RE: Evans Mining Resource, DRMS File M-2024-056
112 Construction Materials Permit Application - Adequacy #3-5 Response

February 25, 2025 Adequacy Letter

March 13, 2025 Adequacy Letter

March 19, 2025 Letter

G-1 Drainage Map

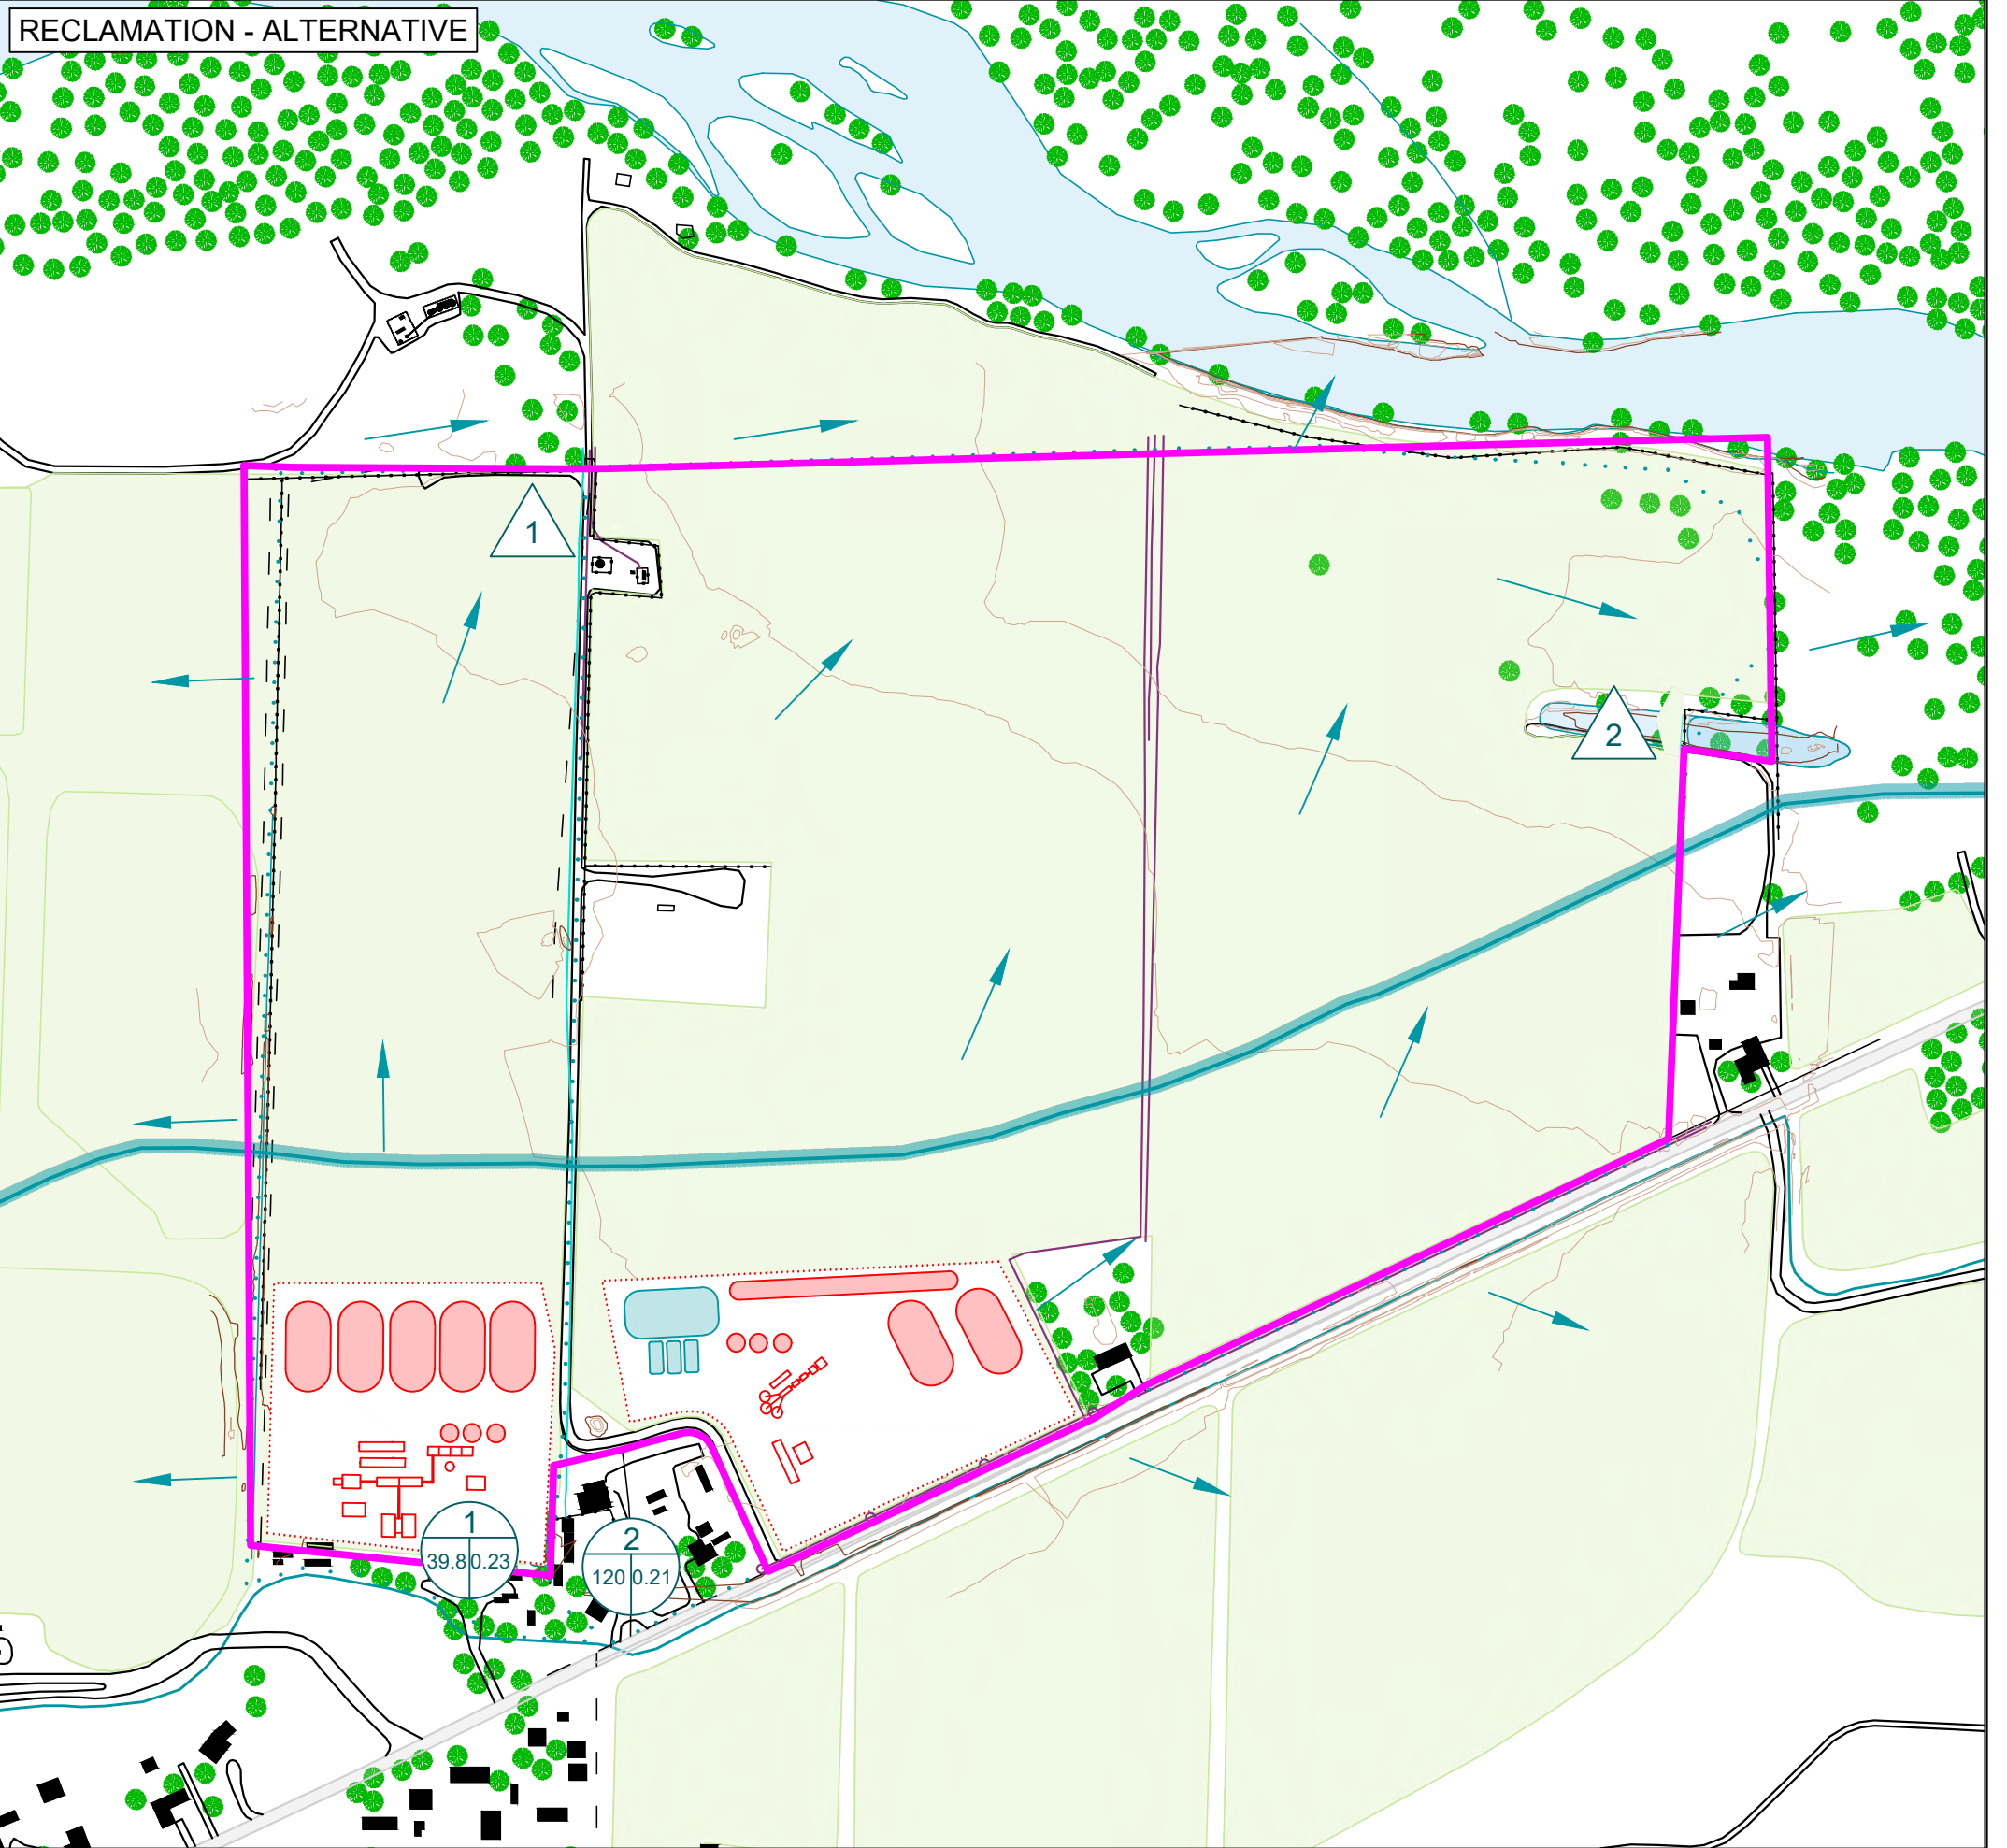
3. *Maps C-2, C-3, F-1, and G-1 depict the inlet/outlet structure in the northeast corner extending outside the permit boundary. Please redraw the permit boundary to show the entire structure within the affected acres and permit boundary and list the acres. If this changes the permitted acres, Per Rule 1.8.1, you will need to submit an amendment application to the Division and place a copy with the County Clerk and Recorder, prior to re-noticing the public for item #1 above. This will set a new decision date for the consideration of the application.*

The inlet/outlet structure location has been revised to stay entirely within the permit boundary. New maps showing the adjusted location are provided. The structure still maintains the same flood protection capacities.

Figure 3. Existing Condition Velocity Map – 36-HR (36,264 CFS)

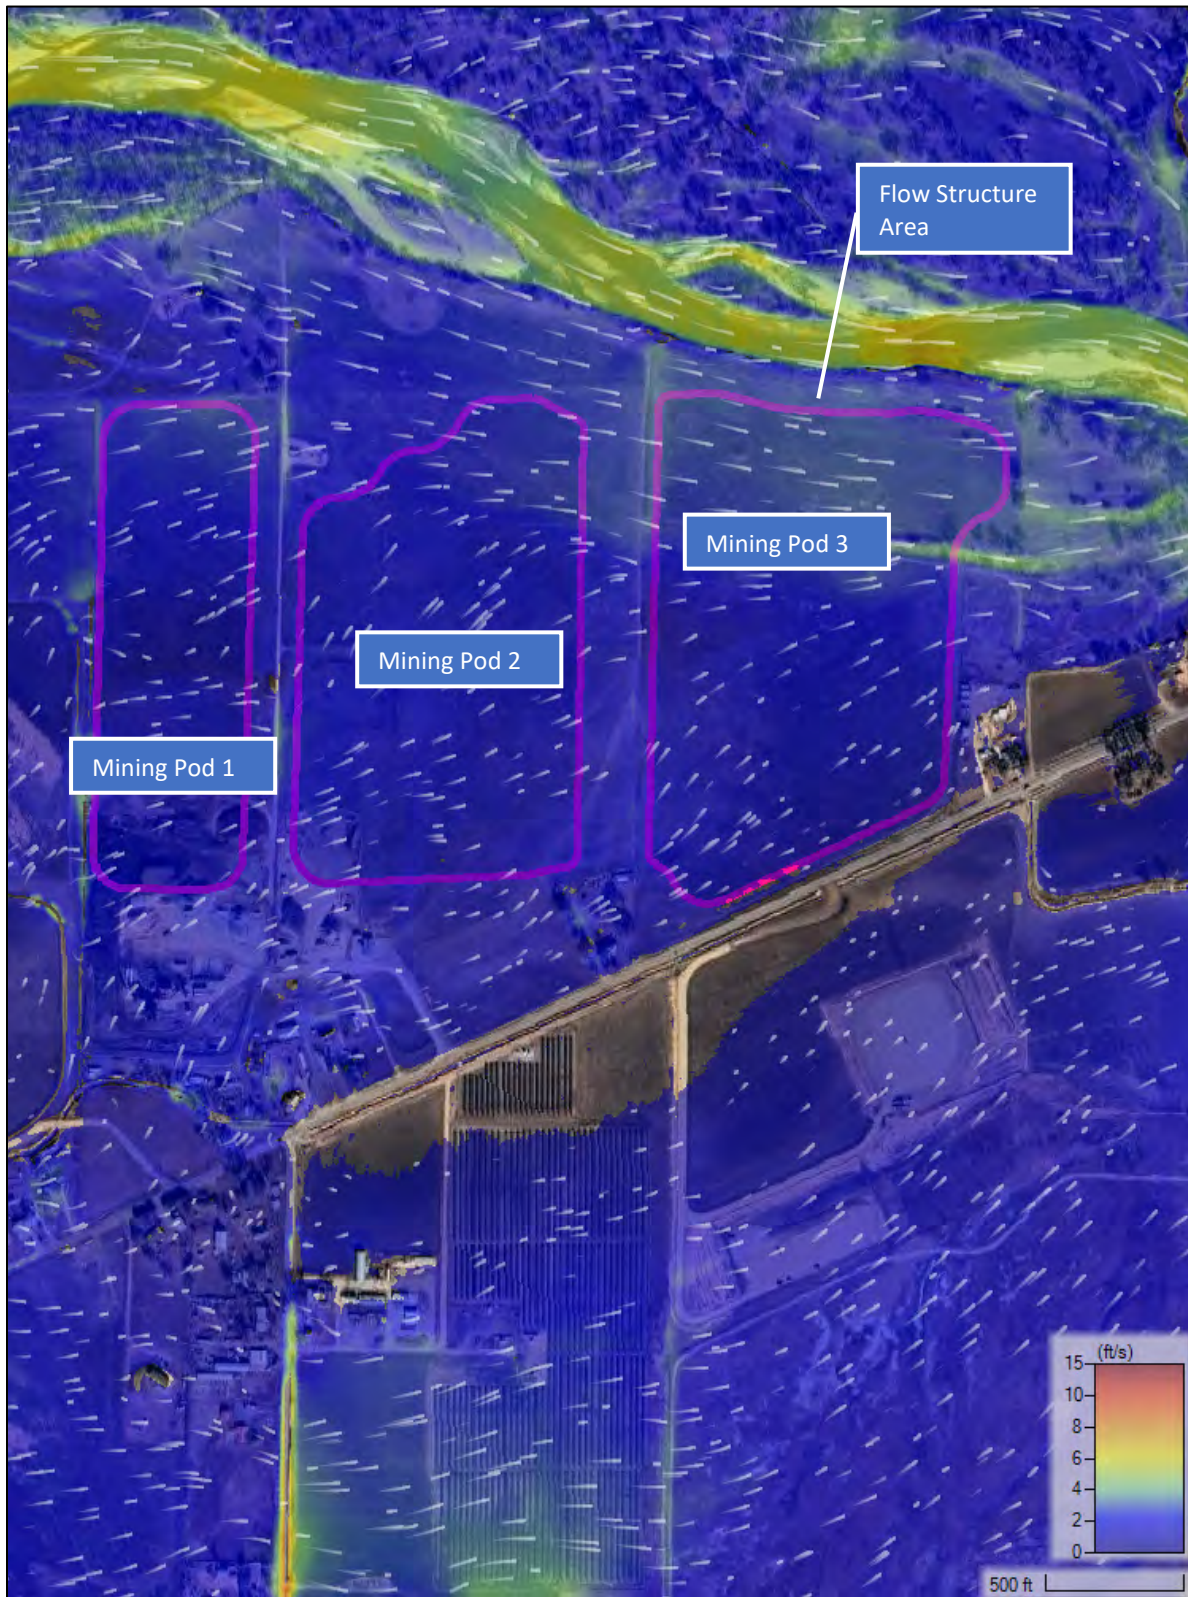
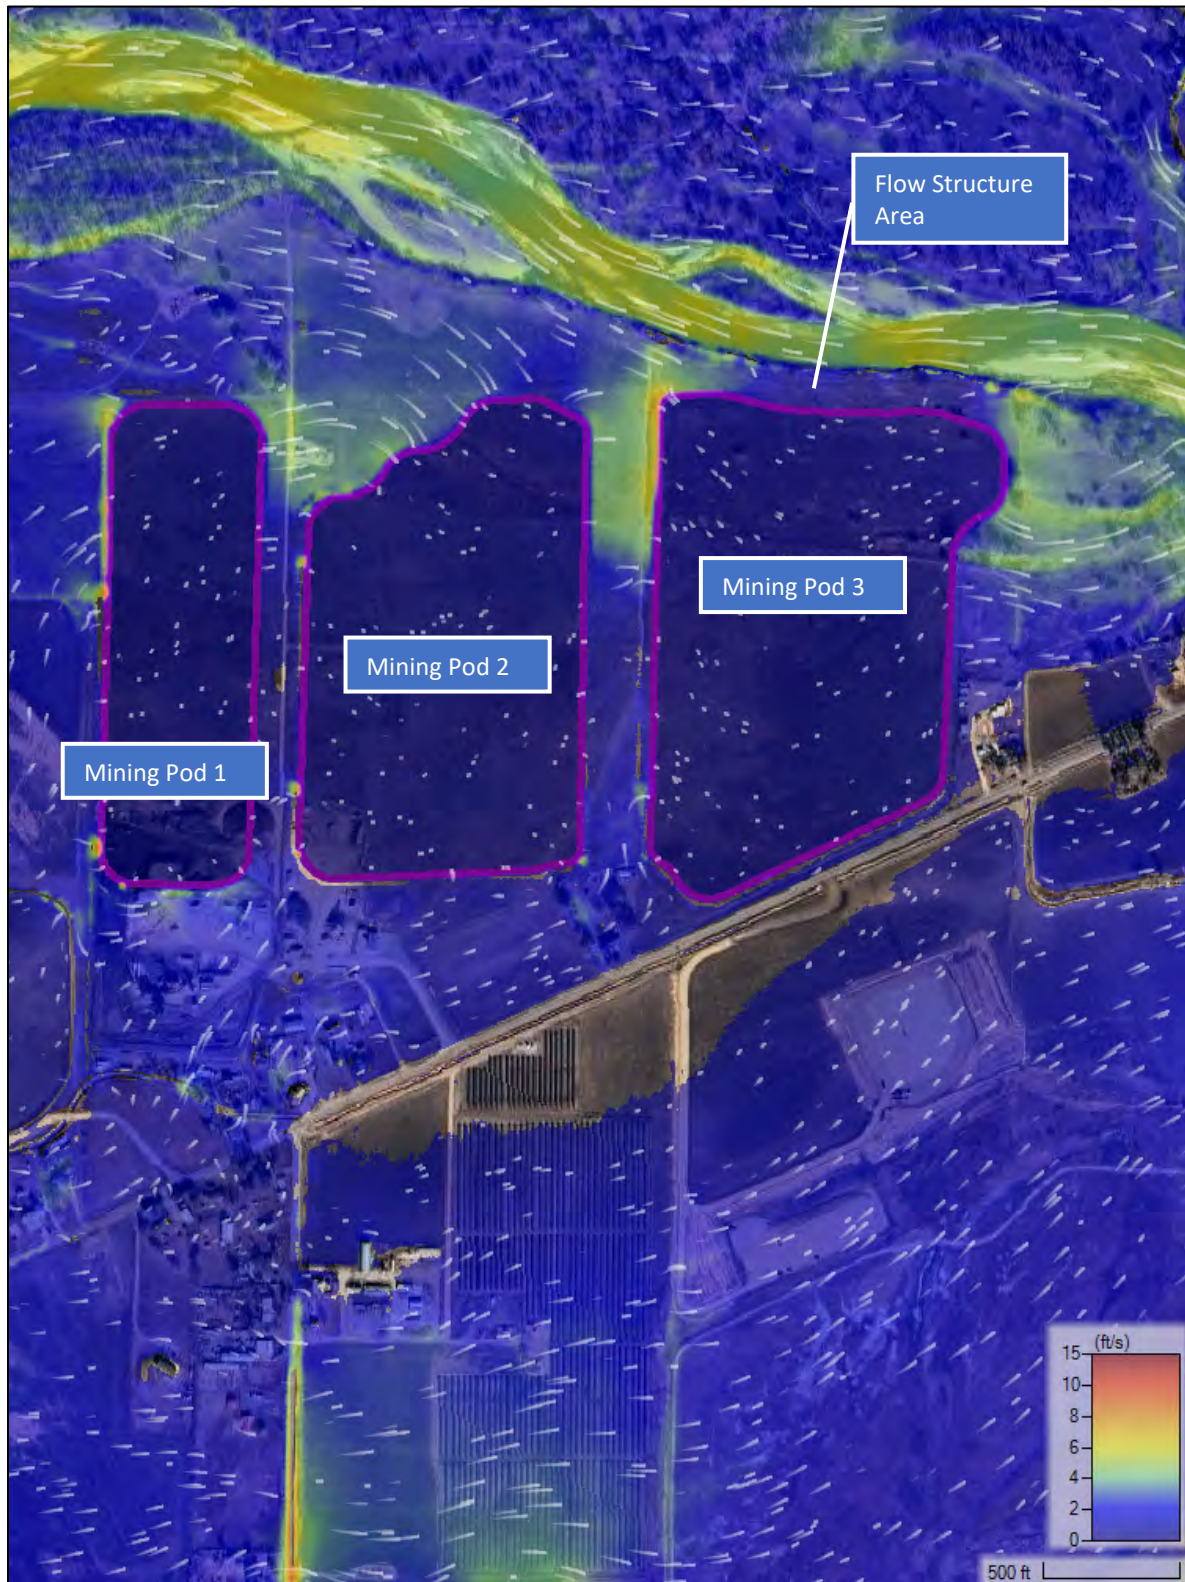
a. The Applicant needs to provide more information on the HEC-RAS model. It appears that this was a 1D model. Explain why a 1D model, rather than a 2D model, is sufficient to estimate flow velocity through the proposed structure.

b. The text on page G-3 discusses the design velocity of 7 feet/second and mentions previous designs that use this value for velocity. The Applicant should provide detailed references for example designs and/or studies that are applicable to this reach of the river. In particular, it would be useful to provide a reference to a related report from the Colorado Water Conservation Board. As an alternative to referencing other designs and reports, the Applicant can provide a detailed report that presents the inputs and assumptions to their HEC-RAS analysis, including cross-sections, the design flow for the 100-year storm, and other important inputs to the model.

A 2D HEC-RAS model has been run, as the Division has required.

A 2D HEC-RAS model for the Evans Mining Resource has been run to confirm the velocity used in the design of the flow structures. A memo on this model and its results can be found in Appendix G-4. Exhibit G has been revised to incorporate this new appendix.

Figure GS-3 Location of Conover Property and Structures

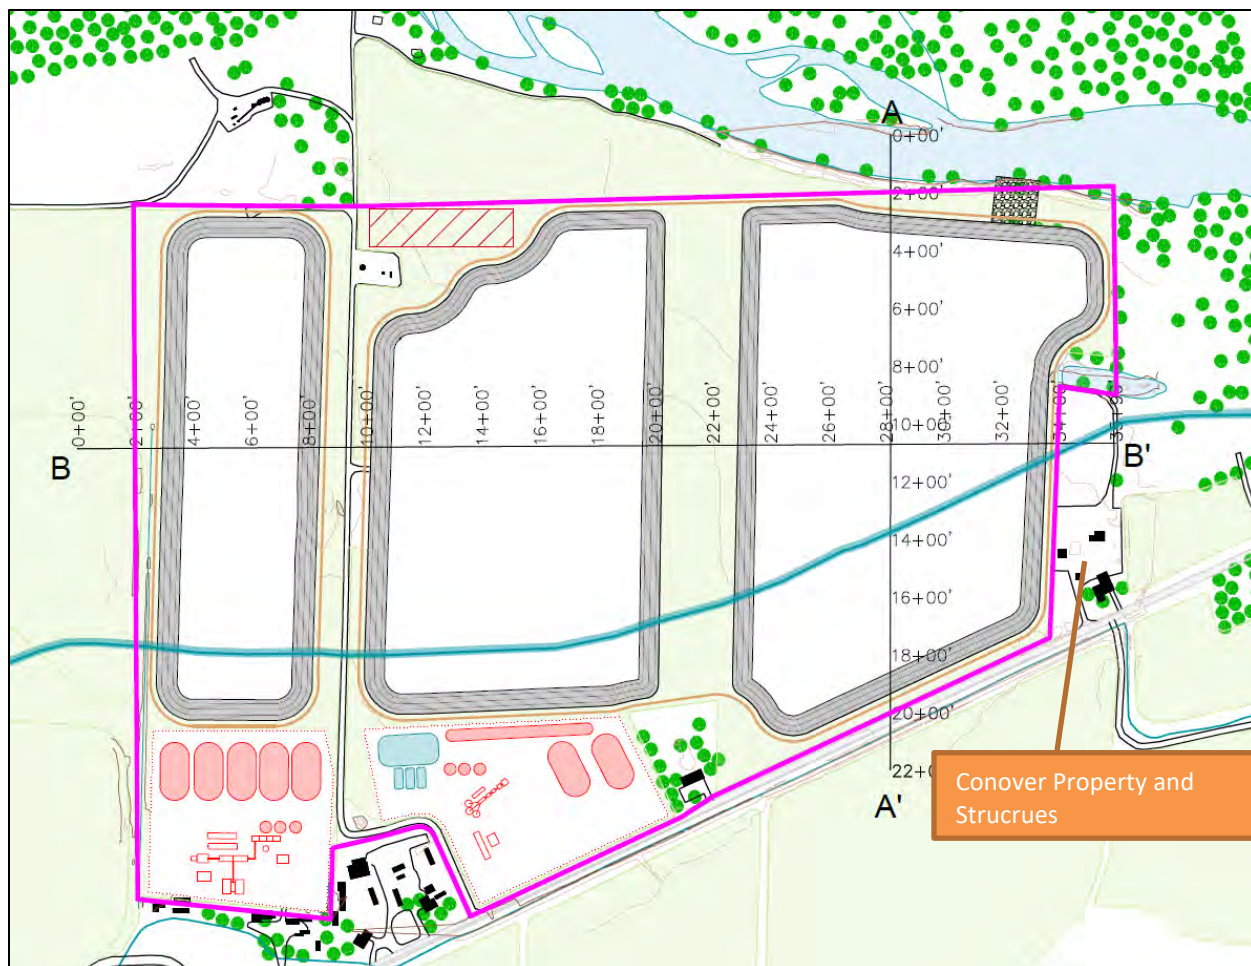
Additional Comment: *Per Rule 6.5, the applicant submitted a Geotechnical Stability Exhibit which states that slurry walls will be 30-ft. away from the edge of mining. Map C-2 shows a minimum 20-foot setback from the edge of the slurry wall to mining and Map F-1 shows a minimum 10-foot setback from the slurry wall to the reclaimed pond. Additionally, the cross sections in C-3 show both, a 10-foot and a 20-foot setback. Please revise the maps and the cross sections to show minimum 30-foot setback from the slurry wall to the edge of mining consistent with the Geotech Stability Exhibit text. Additionally, the Division is particularly concerned with the stability of the slopes on the east side of the Phase 6 area, adjacent to the Conover Property. Based on the Weld County Property Portal map, the adjacent property contains a residence, outbuildings, a driveway, and a groundwater well, within 200 feet of the affected area. Per Rule 6.5(2), please submit a slope stability analysis for the east side of Phase 6 and which addresses structures or facilities that could be adversely affected by slope failure in this area.*

The geotechnical stability exhibit has been revised to state the minimum setback is 10-ft from the slurry wall to the crest of the reclaimed pond slope. The analysis in the geotechnical stability exhibit is unchanged by this revision.

An additional analysis has been incorporated into the geotechnical stability exhibit. It addresses the Conover Property.
